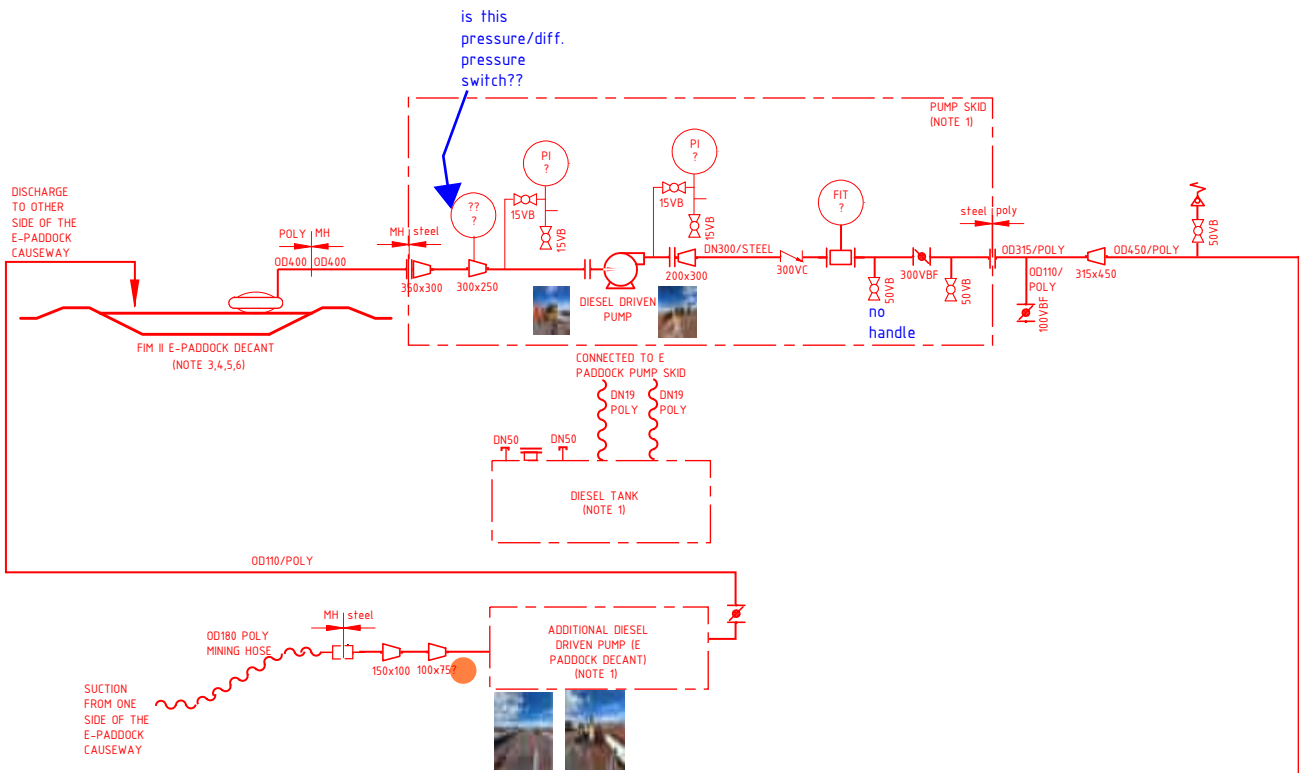
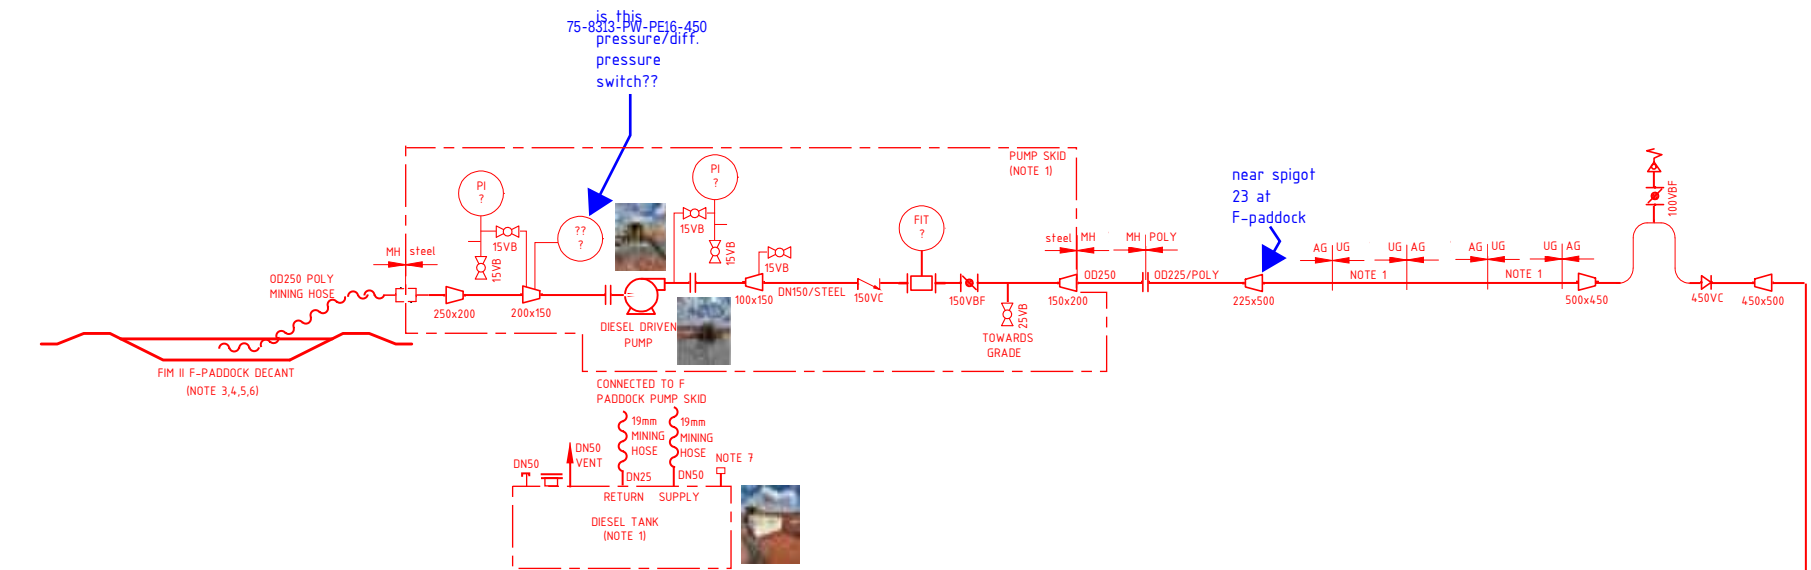
- NOTES:
1. FOR DETAILS OF VENDOR SKID, REFER TO SUPPLIER DOCUMENTATION.
 2. UNDERGROUND PIPING CANNOT BE VERIFIED VISUALLY AND SO CANNOT BE CONFIRMED. TBC - BY CLIENT.
 3. NO LEVEL INSTRUMENT SEEN IN FIELD.
 4. NO ANTISCALANT DOSING SYSTEM SEEN IN FIELD.
 5. NO POTABLE WASH UNIT SEEN IN FIELD.
 6. PUMP NUMBER, INSTRUMENT DESCRIPTION/TAG NUMBERS NOT FOUND IN FIELD.
 7. UNIDENTIFIED FITTING
